SEWAGE DISPOSAL SYSTEM

SUBDIVISION Burntwoods ROAD 140²¹/₂ Celbridge Court LOT 5, Section 3

PROPERTY OWNER Louis Spisso

RE: Septic System Design
Burntwoods Subdivision
Section III - Lot 5

Burntwoods Lot 5 sec 3

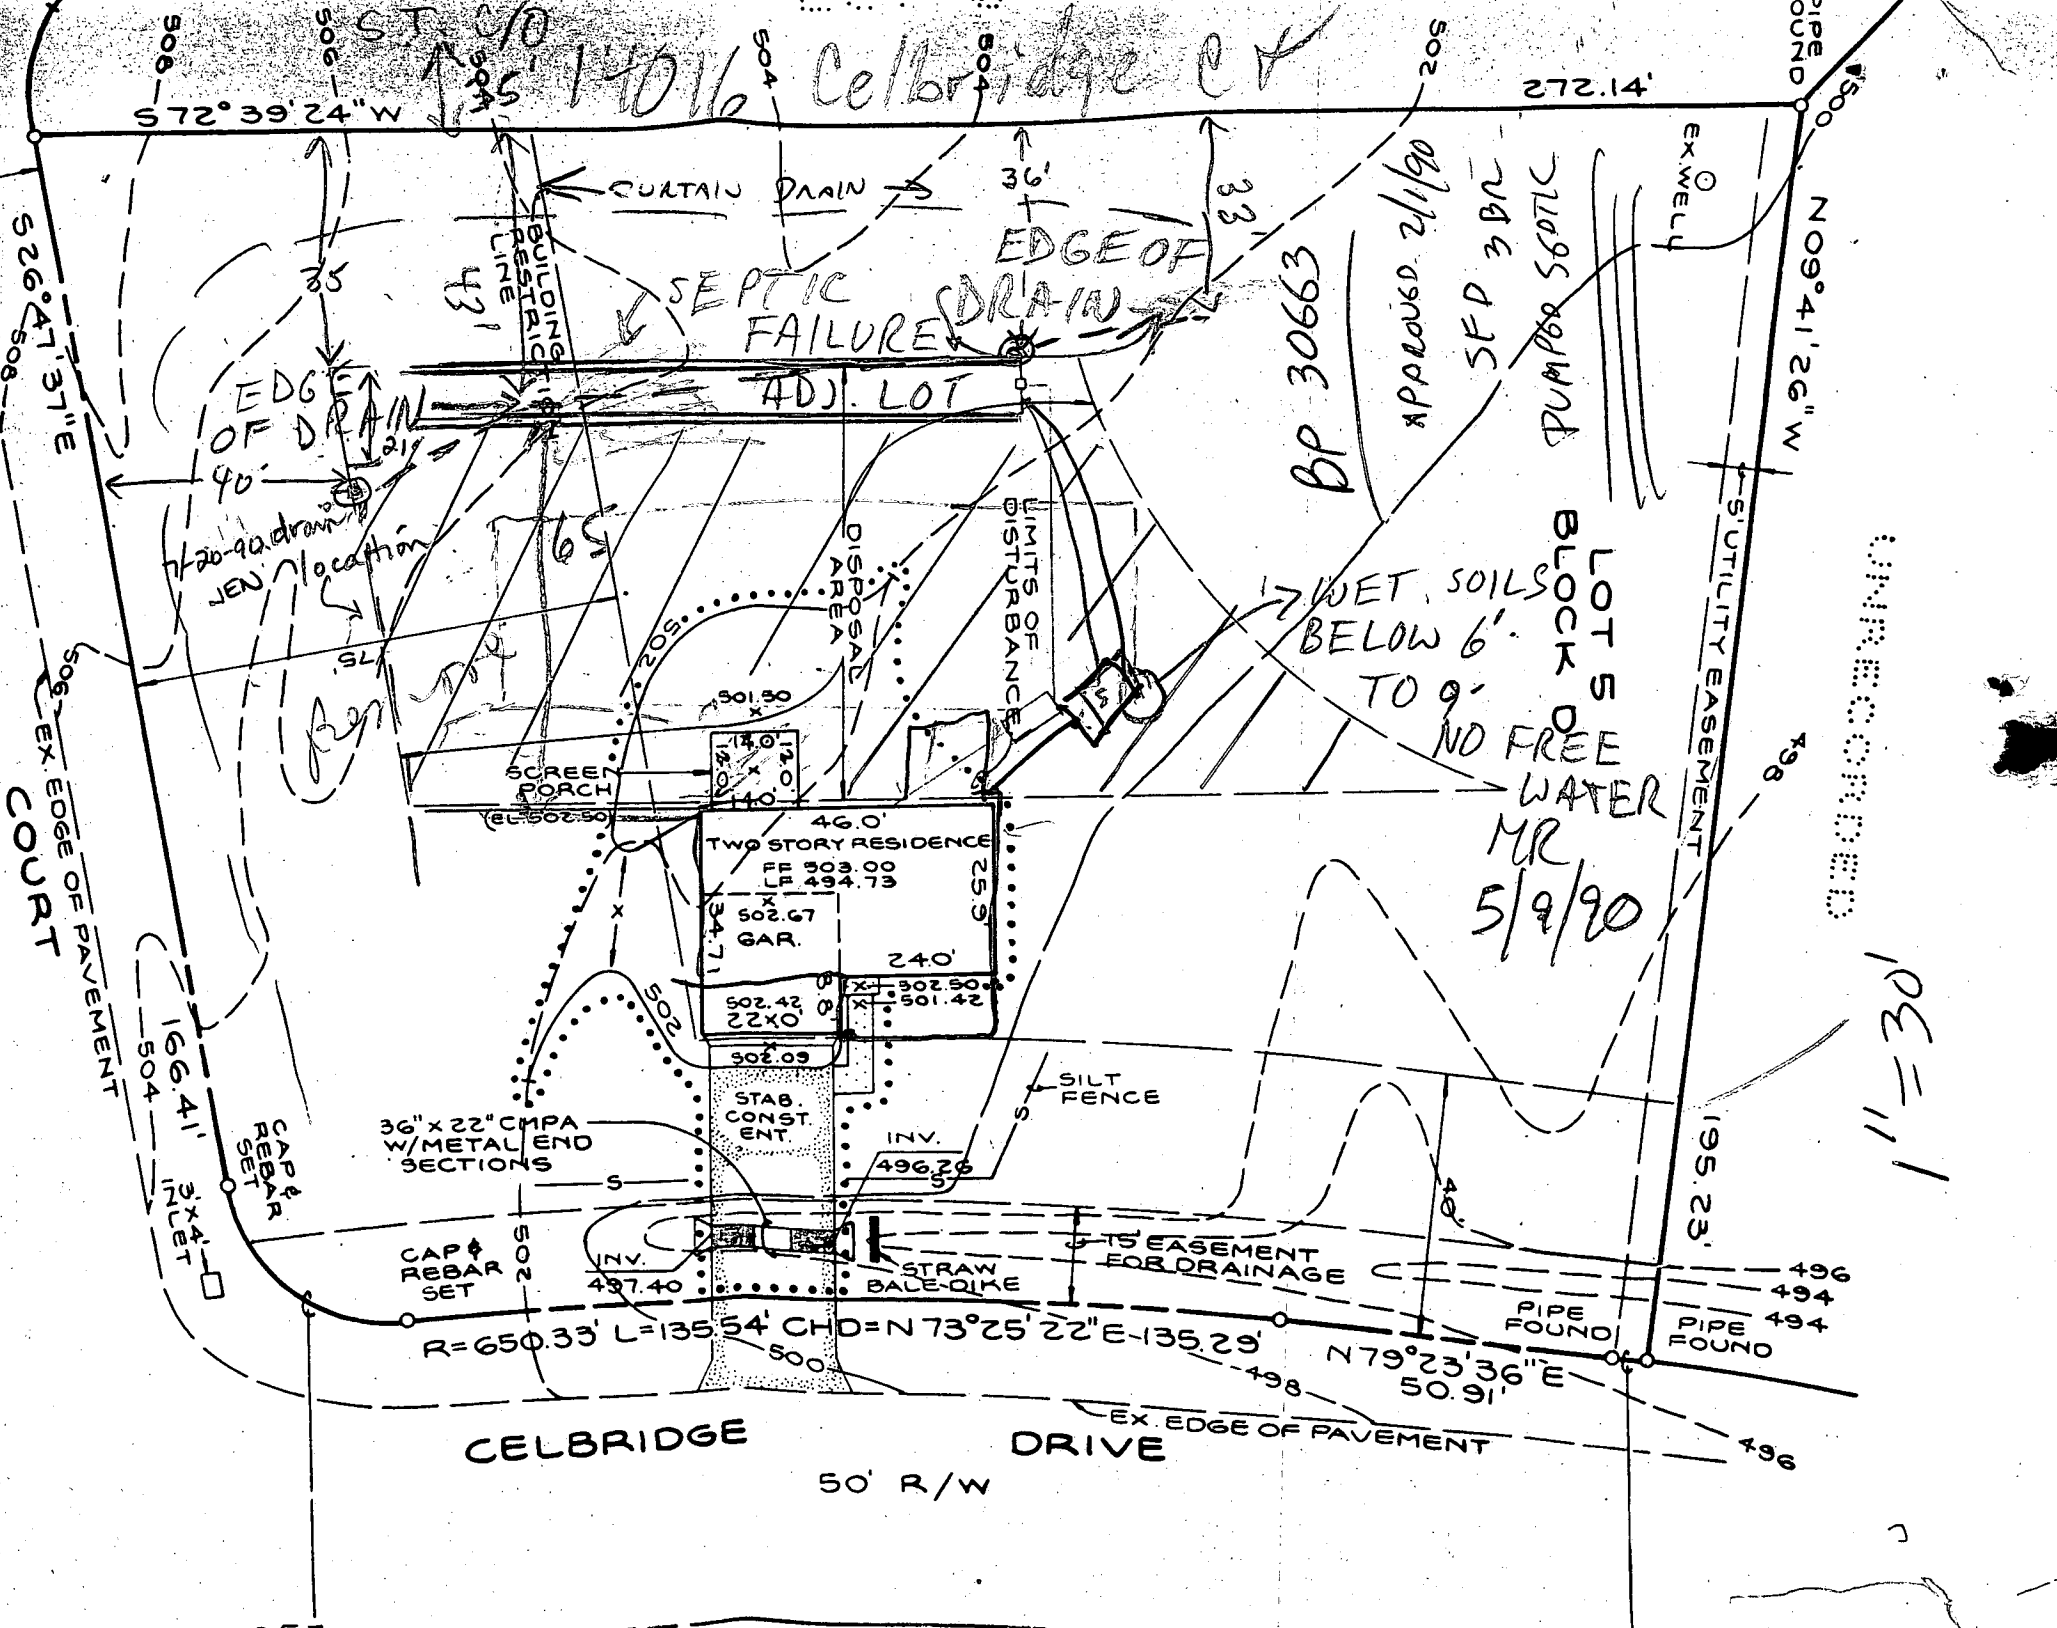
During inspection of this lot, I observed the location of the curtain drain to be 43' off the property line (as indicated by a stake), and about 100' down the property line, the drain was observed at 33' off the property line. The distance from the curtain drain to the house under construction was about 65'. The location of the curtain drain appears to be at the high part of the SDA. Additionally standing water areas were observed at the surface of the curtain drain; this standing water had the appearance & odor of septic effluent.

A 9' hole was dug near the s.t. location, and wet mottled soils were observed at depths below 6'. Based upon this observation, I would recommend a top-seam tank.

TRENCH PLAN

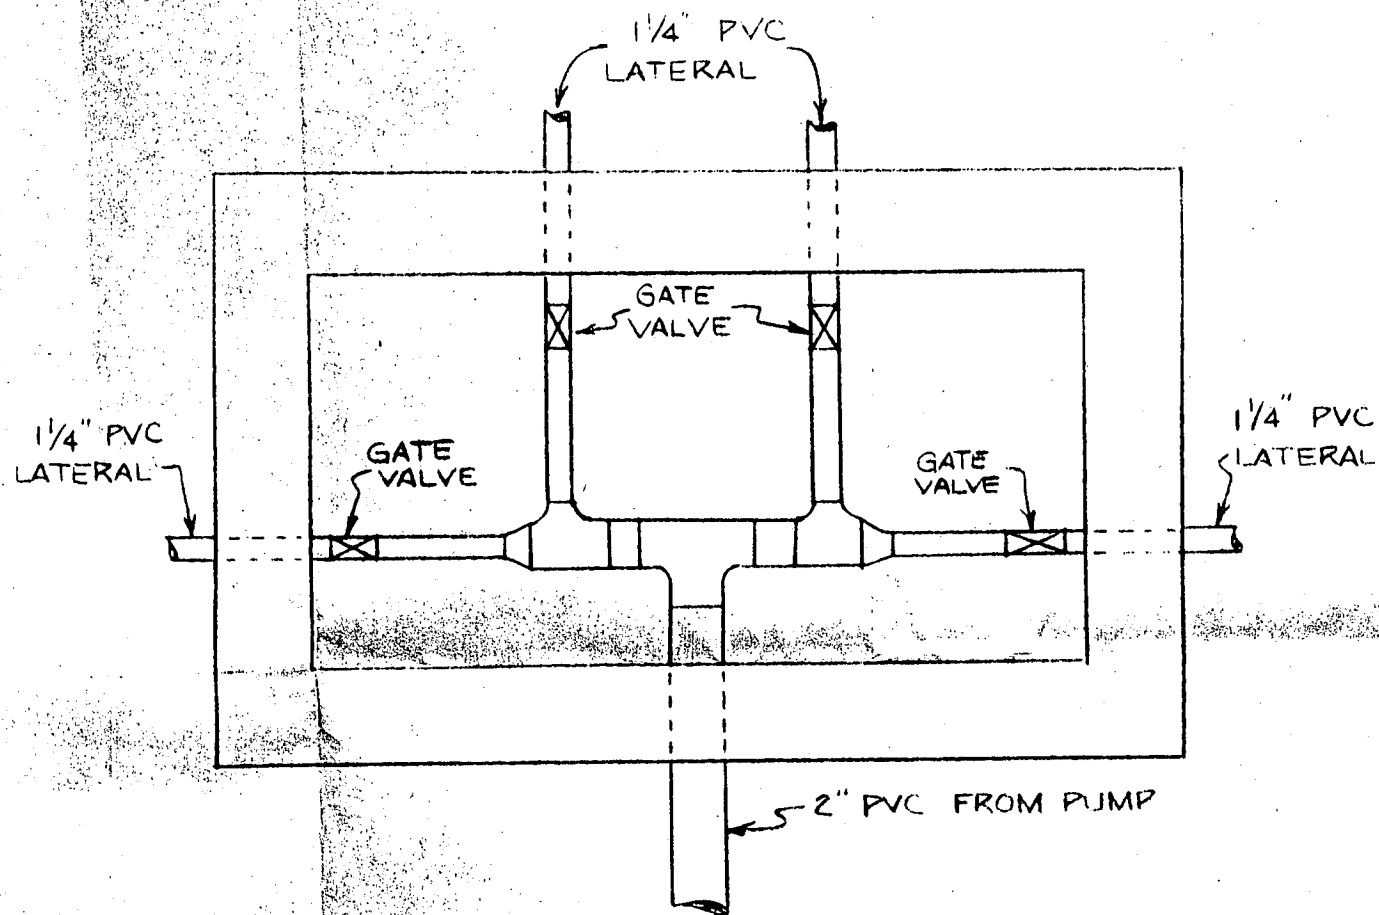
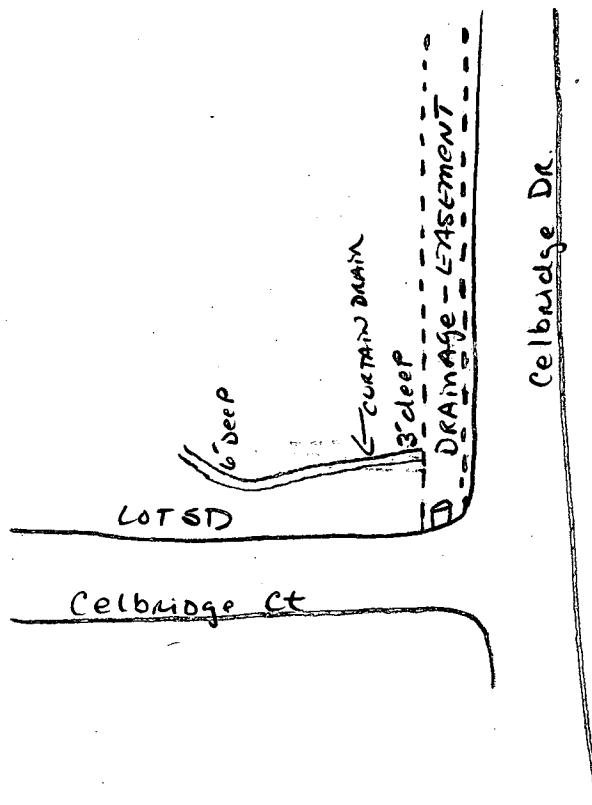
7-26-90 spoke to ^{Jim} Chase re: spacing of trenches. Decrease in distance ~~of~~ to 5 ft between trench edges will not change effectiveness of system. Distance from pump tank to valve box is not critical. Pump has been oversized to handle several changes in system. JEN
